CITY OF OLYMPIA
MULTI-FAMILY RESIDENTIAL
Chapter 18.170

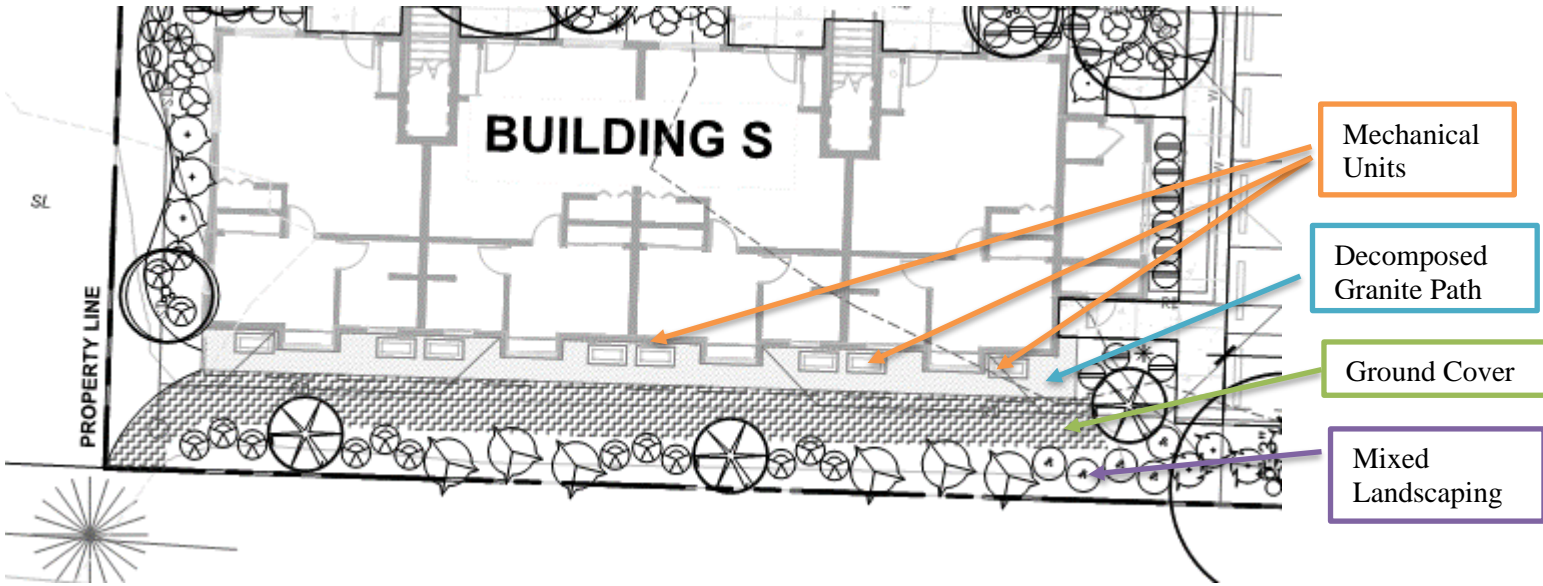
- The landscape plan will need to clearly show 1) the location of all above- or at-grade mechanical equipment, and 2) and appropriately scaled screening of the equipment. Provide photos and cut sheets (if applicable) or screening choices.
- Locate mechanical equipment and utility vaults on the least visible side of the building and/or site.
- Screen at-grade mechanical equipment utilities with vertical plants such as trees, shrubs or ornamental grasses.
- Screen or paint wall-mounted mechanical equipment to match the building.

The only mechanical equipment that will be visible by residents are mini-split heating and cooling units behind each building. Each apartment has a unit on the ground at the base of the building (see Building S below) – other mechanical equipment such as fire apparatus and connections will be in separate rooms or enclosed. The cooling units are on concrete pads with a crushed gravel/granite pathway in front of each for maintenance purposes.

The mechanical equipment is tucked within building bays and will not be visible from adjacent roadways or from adjacent dwelling units. The pathway is open and accessible, the hierarchy of landscaping, at full maturity, from ground cover to a mix of shrubs and trees along the fence line will provide a pleasant screen between building and
